THE TOPEKA LANDMARKS COMMISSION MEETING

A G E N D A

Thursday, April 14, 2016

Topeka Landmarks Commission
Certified Local Government
Certificate of Appropriateness
National Historic Register Project Review
TOPEKA PLANNING DEPARTMENT

1 SITE PLAN
C-1 1"=10'-0"

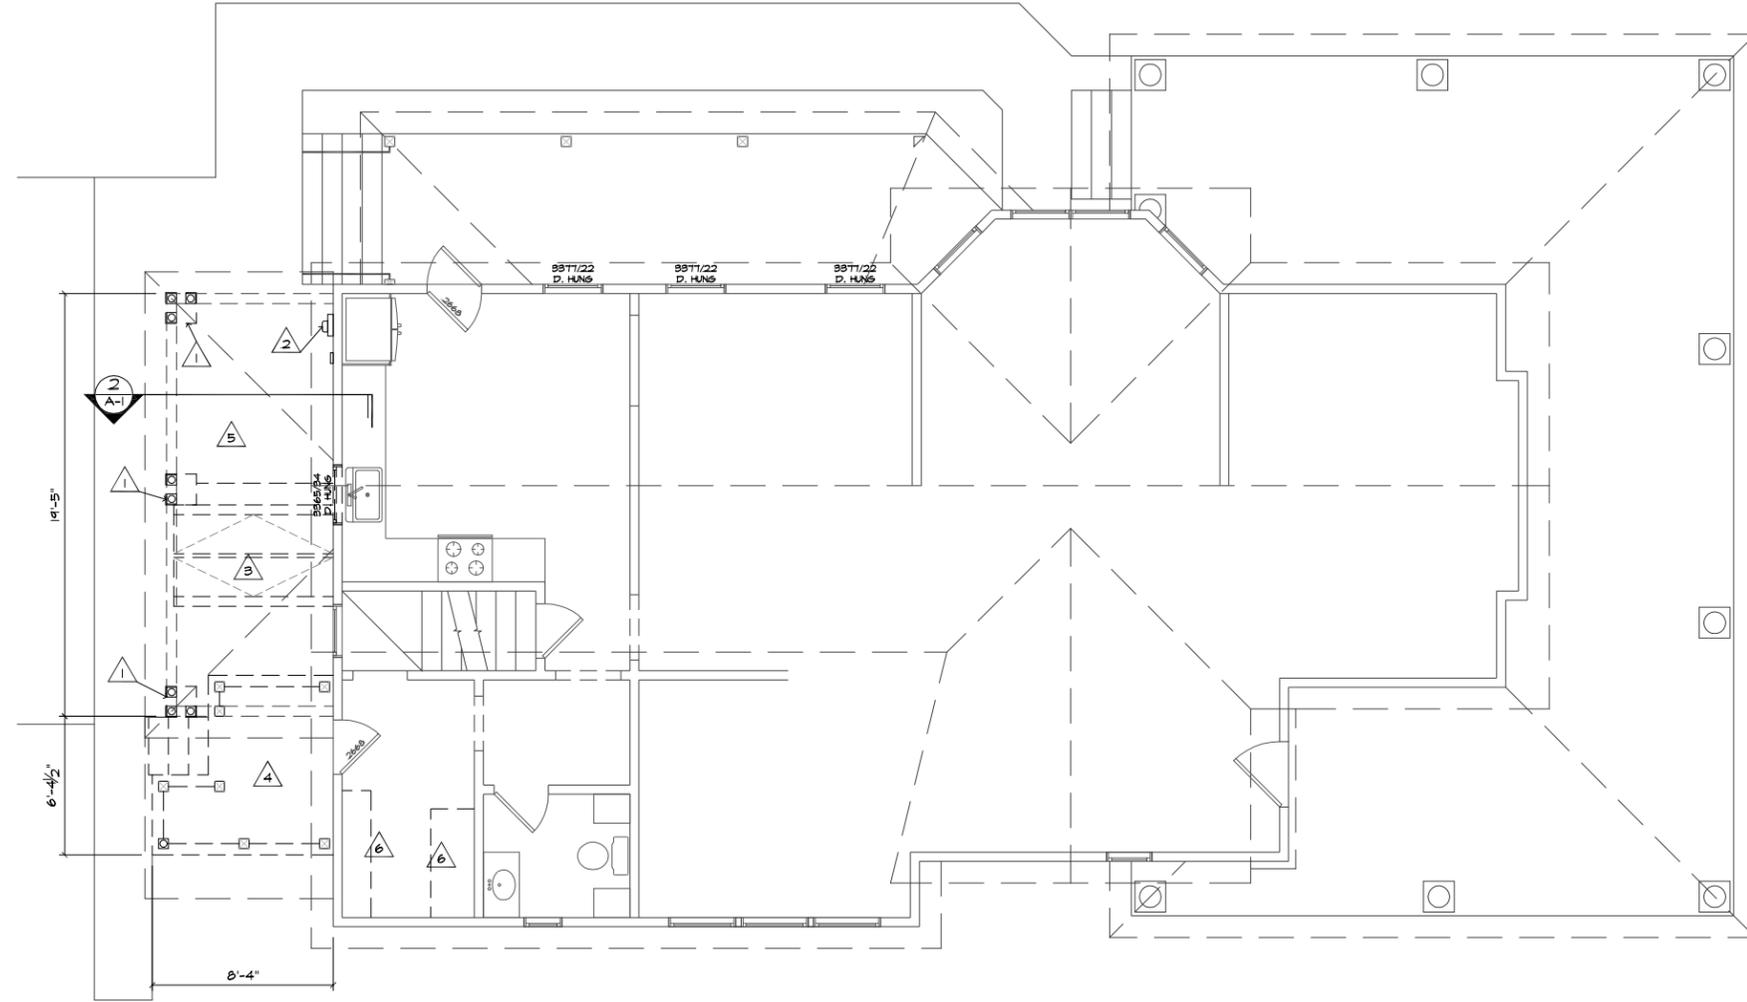
Analysis: The proposed addition will not remove or destroy any distinctive materials or character-defining feature of this property. The proposed addition will be compatible with the massing, size, scale and architectural features that define the historical character of the property.

Staff Recommendation: Therefore, in light of these standards and the preceding analysis, Planning Staff recommends a finding of **no detrimental effect** on the historic integrity of the property, nor its vicinity within the Potwin National Historic District.

CLGR16-02 by USD 501 - Topeka High School, 800 SW 10th Ave.

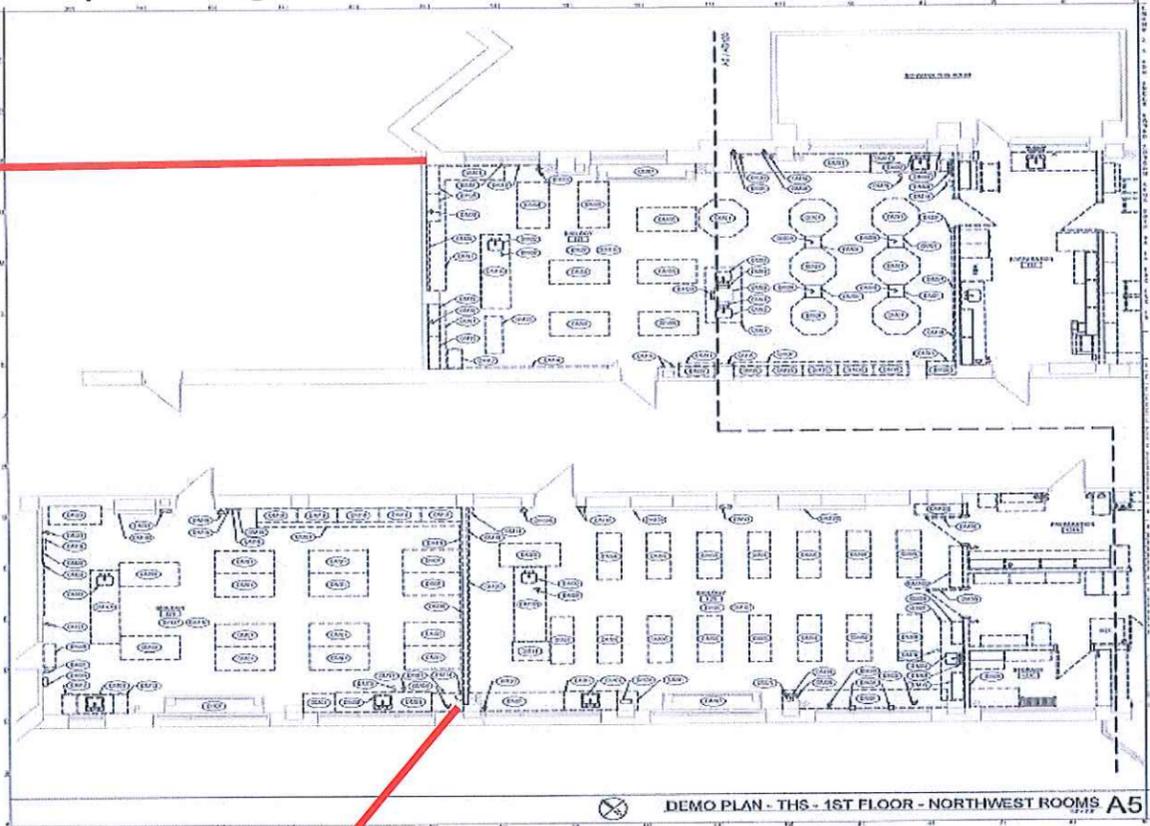
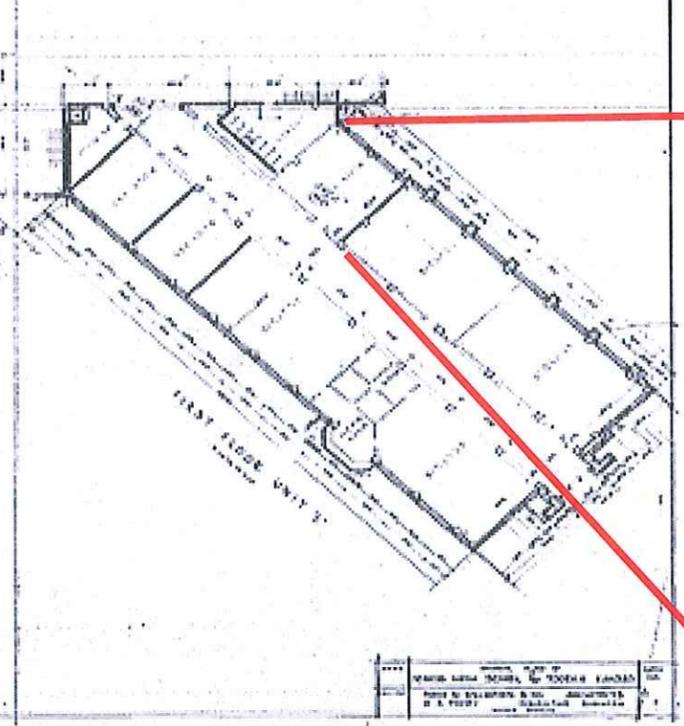
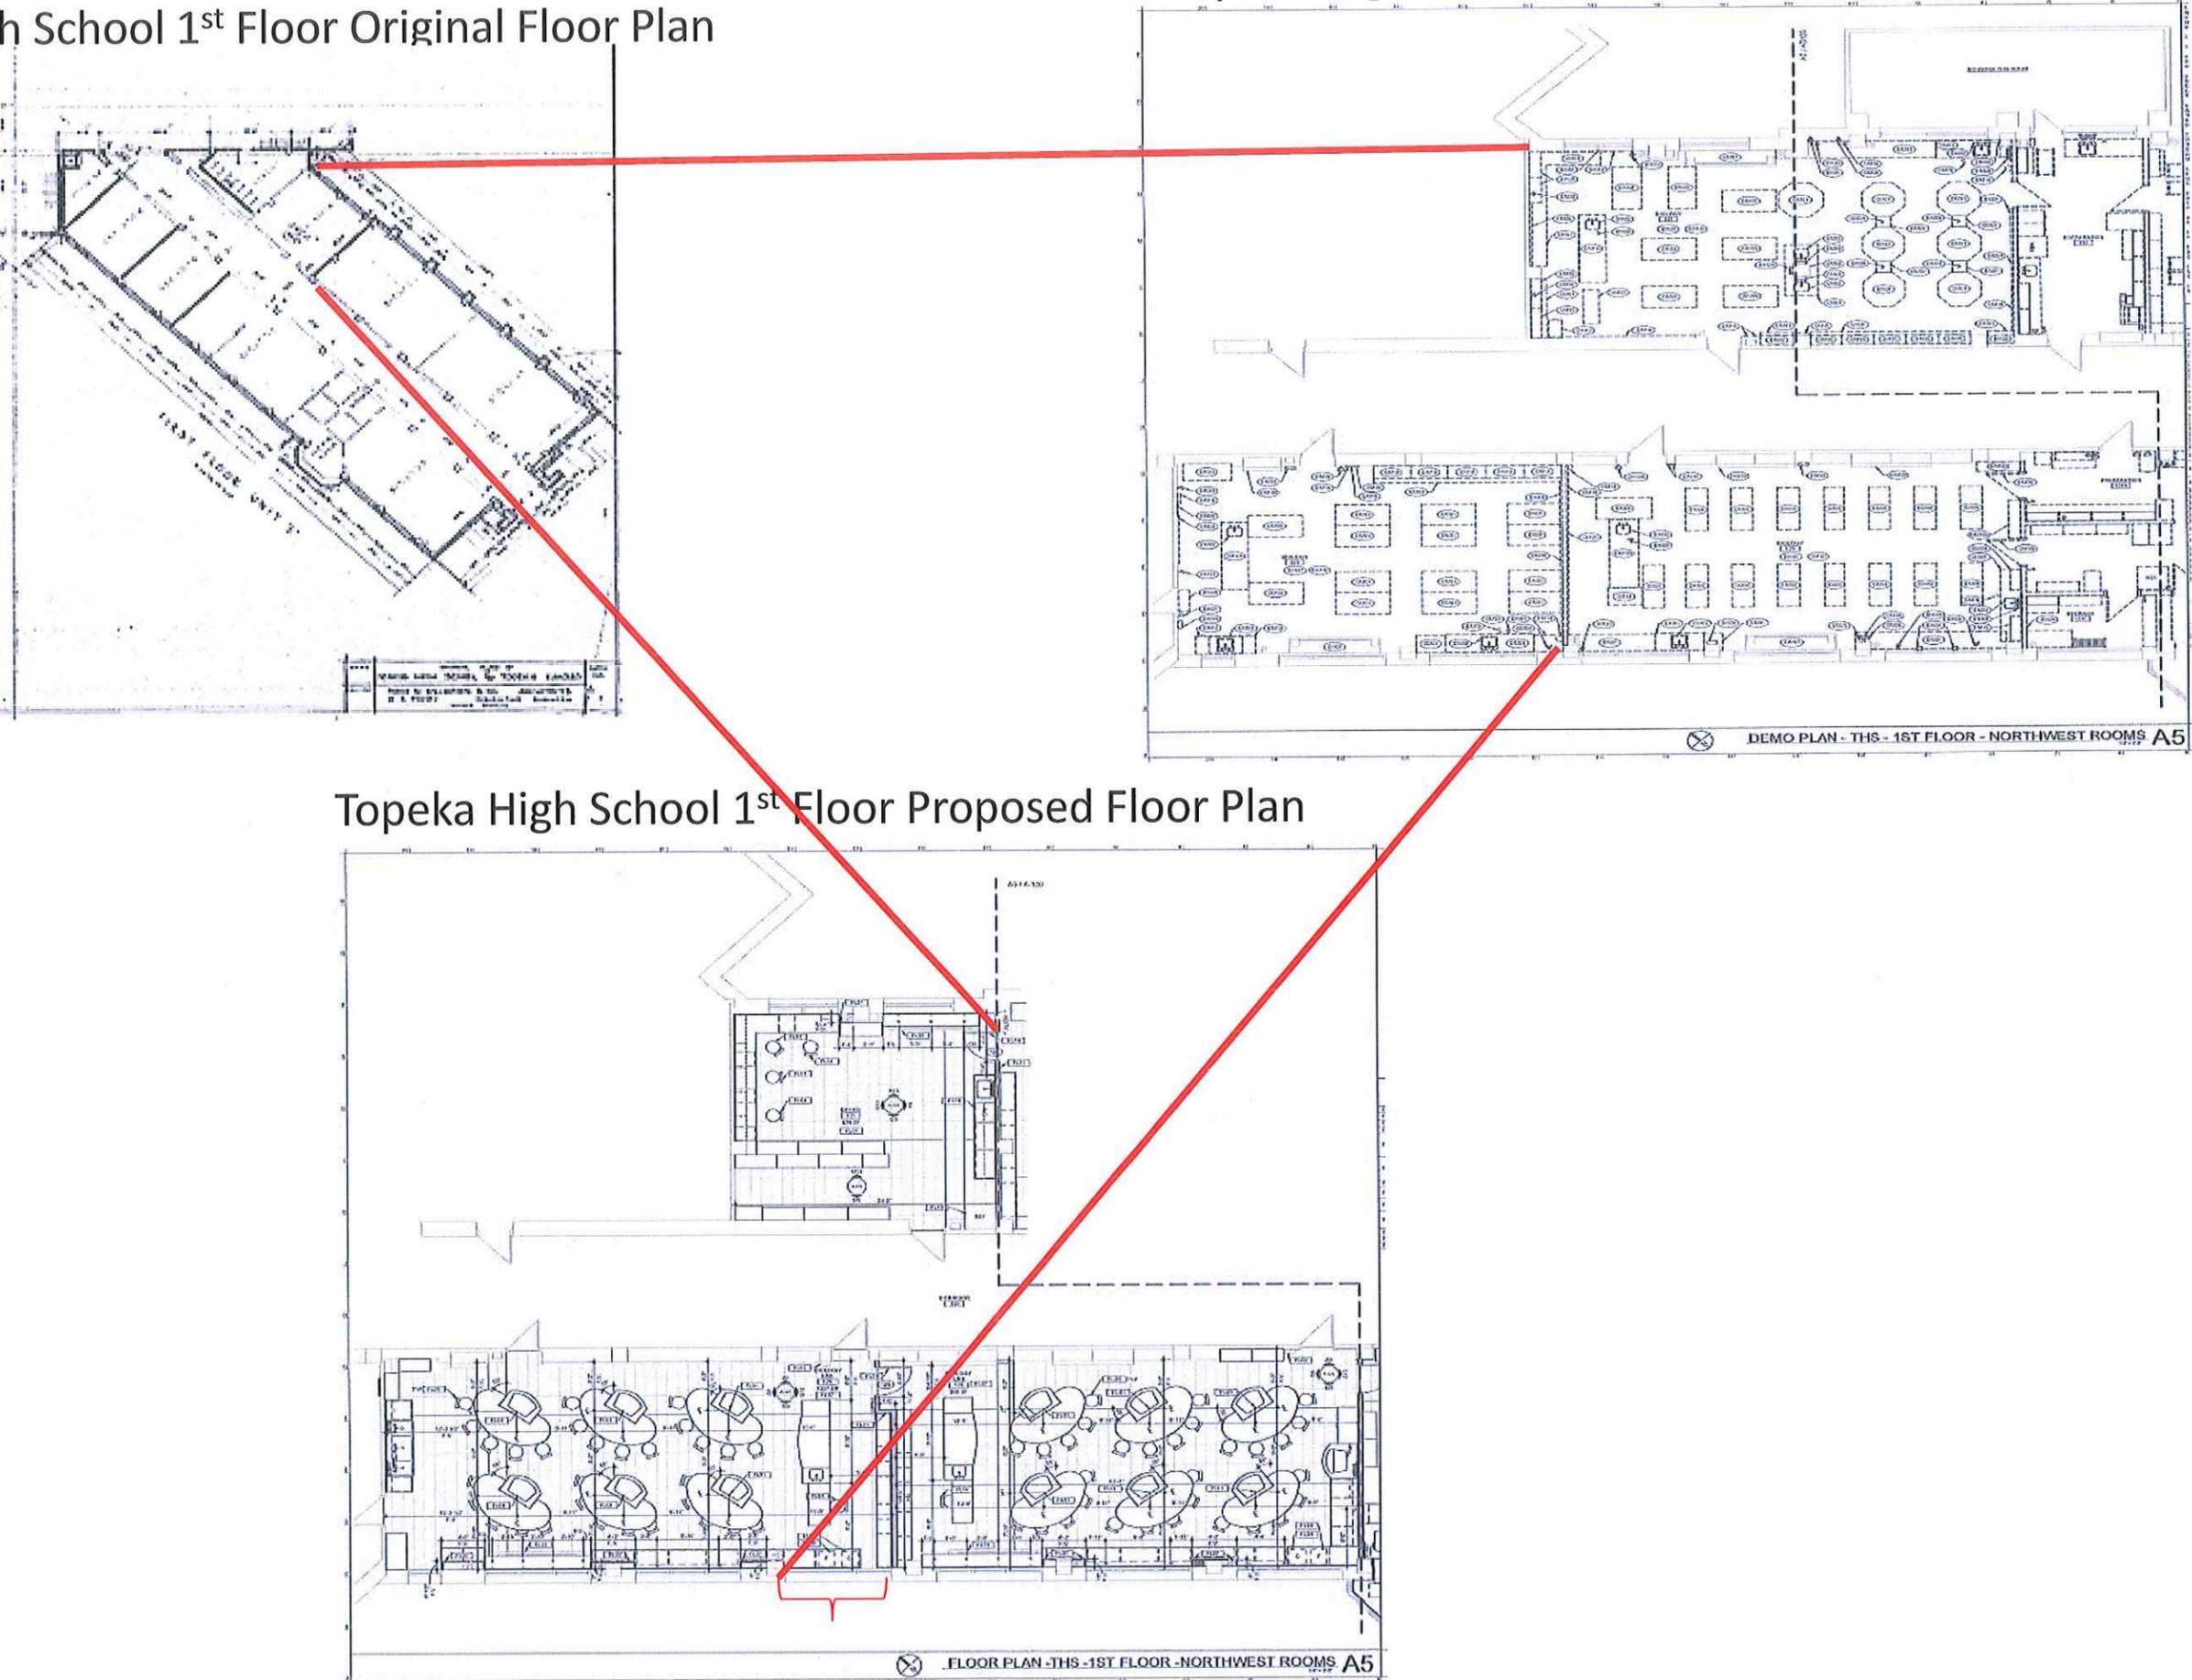
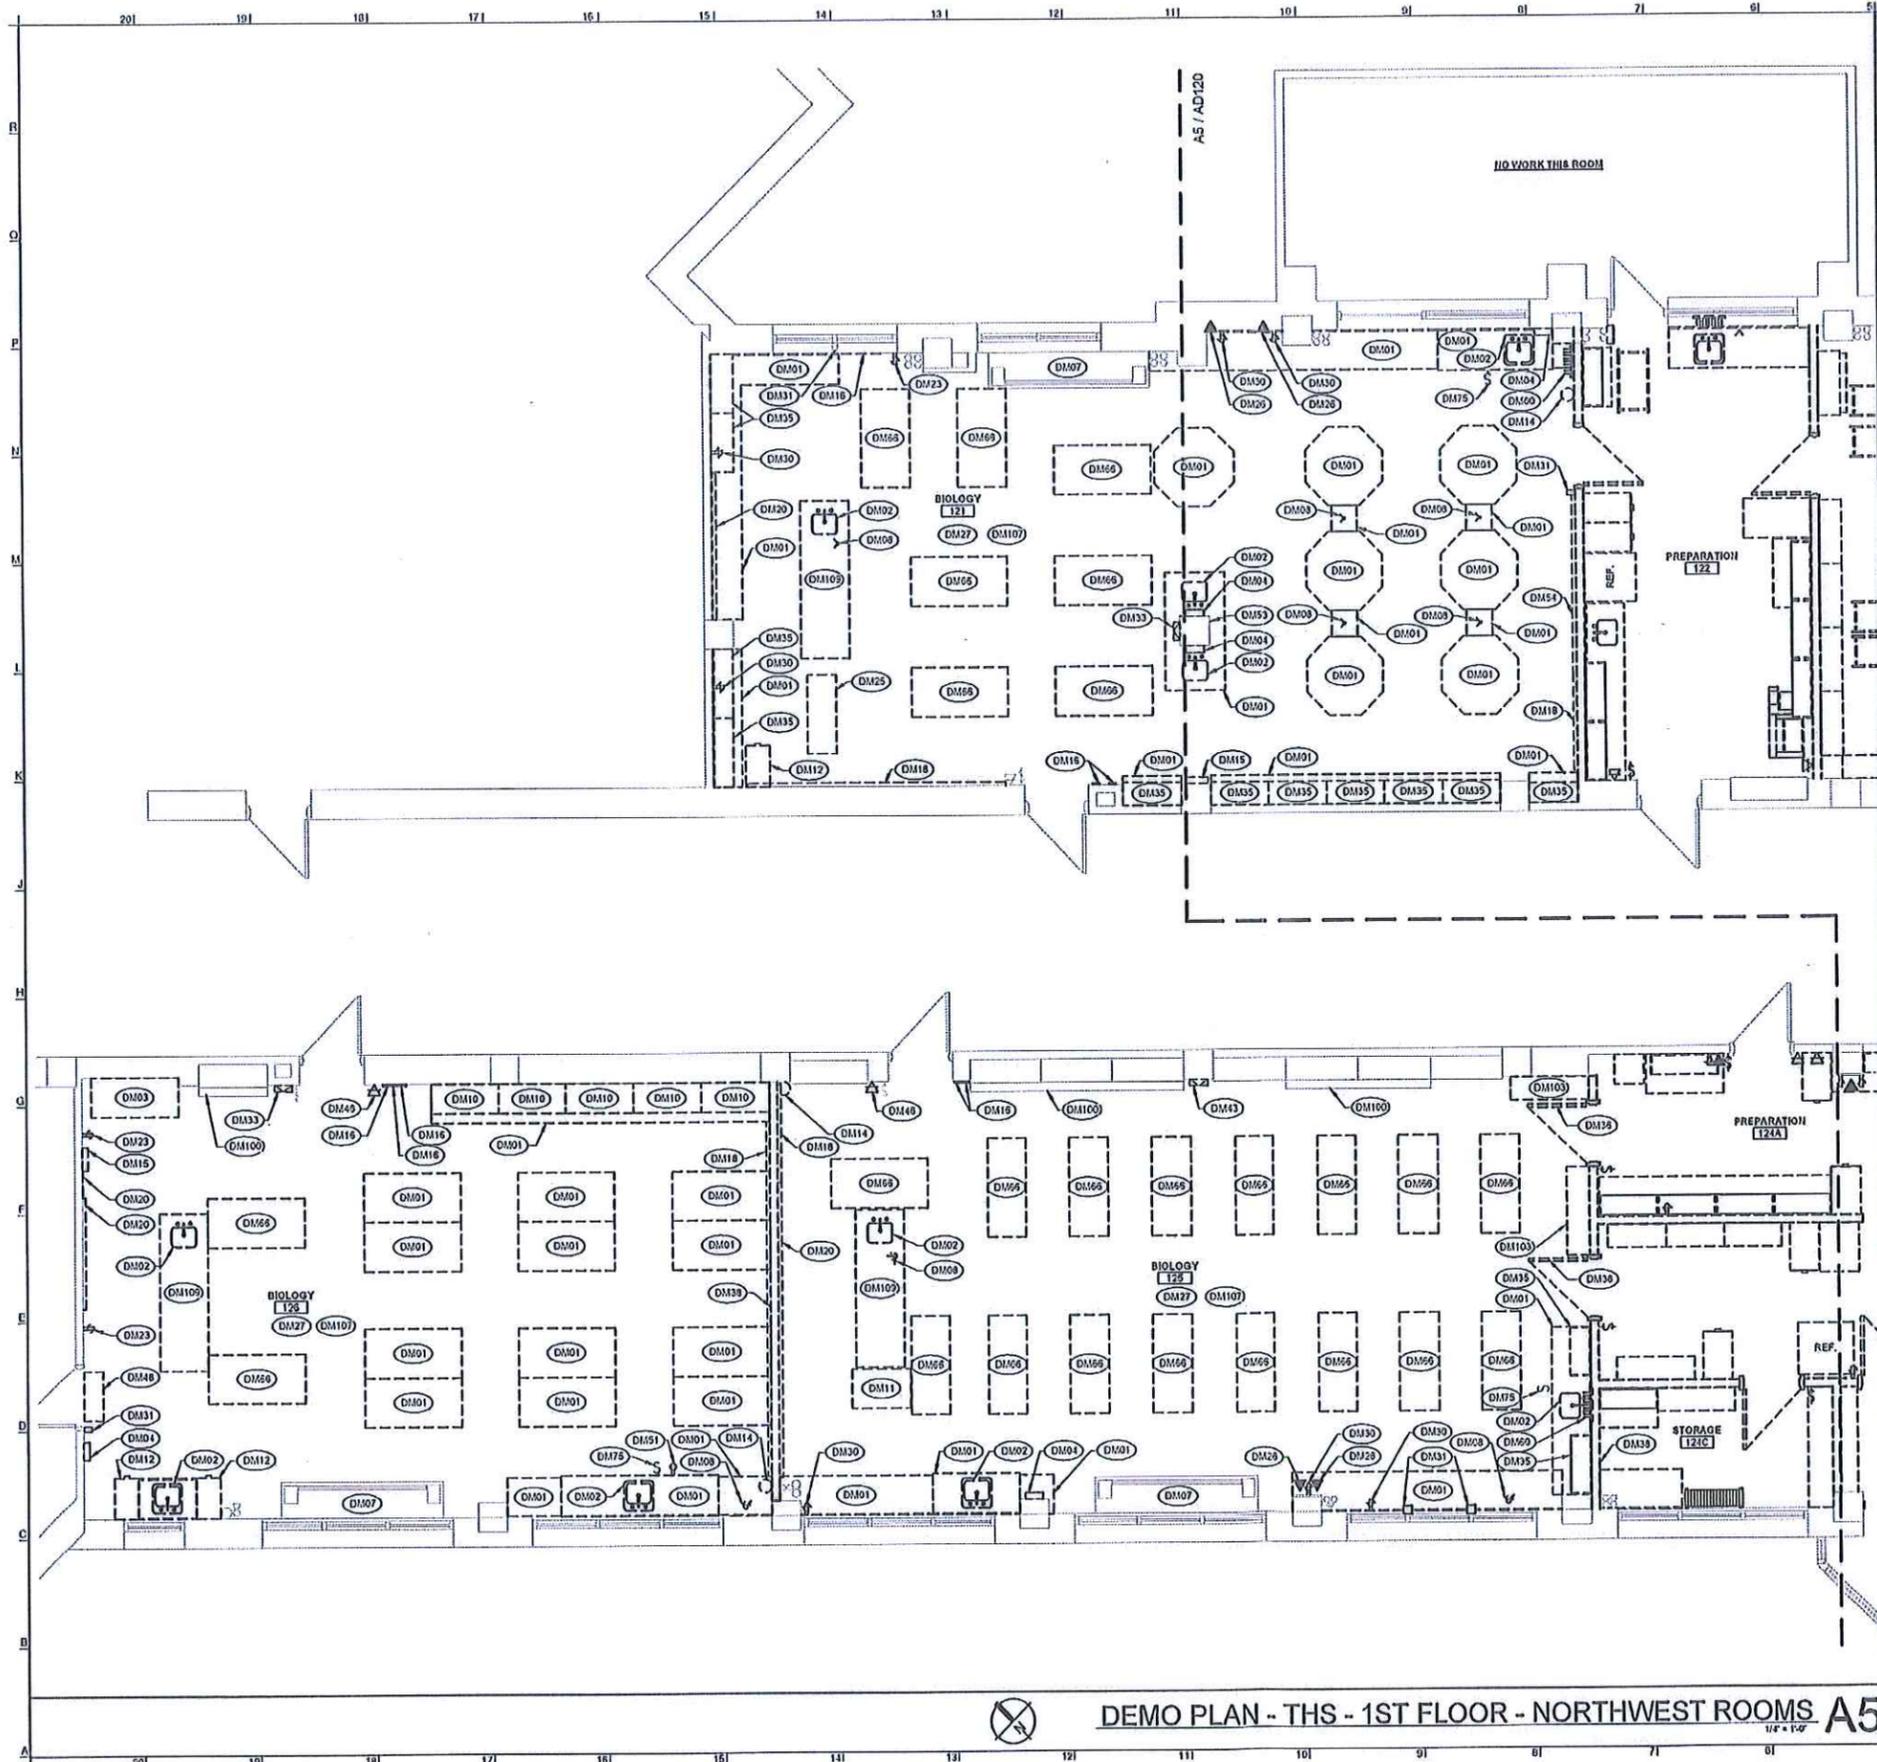
Analysis – One portion of this project will remove an original wall between two classrooms, and construct its replacement approximately 15 feet to the east. The result of this modification will be the slight reduction in size of one classroom, and the expansion of its adjacent classroom. Within the confines of this specific project, several original walls have previously been removed to accommodate student and faculty needs.

A second portion of this project is to remove an original wall between classrooms, and construct a new wall a distance of approximately 15-feet to the west from its current location. This removal and replacement will result in two classrooms of equal size and function, and will also convert the entirety of a bay window from a storage space to useable classroom space.

Following this guidance, the walls proposed for removal, and the construction of their replacements are located within the interior of classrooms, and are not visible from the more public space of the primary hallway, nor are they visible from any exterior entrance to the building. Additionally, the removal and replacement of each wall will avoid any substantial modification to the historic character of all affected classrooms. While it is recognized that this project does remove two original walls of the structure, this action lies within an area of secondary concern for the preservation of the building’s overall historic character, as suggested by the *National Park Service Incentives - Guide to the Federal Historic Preservation Tax Credit Incentives Program for Income Producing Properties Briefs for Historic Building Interiors*.

Planning Staff Recommendation: Based upon an evaluation of the project according to the Secretary of the Interior's Standards for Rehabilitation, it is Staff's finding that the proposed project will **NOT** damage or destroy the historical integrity of Topeka High School.
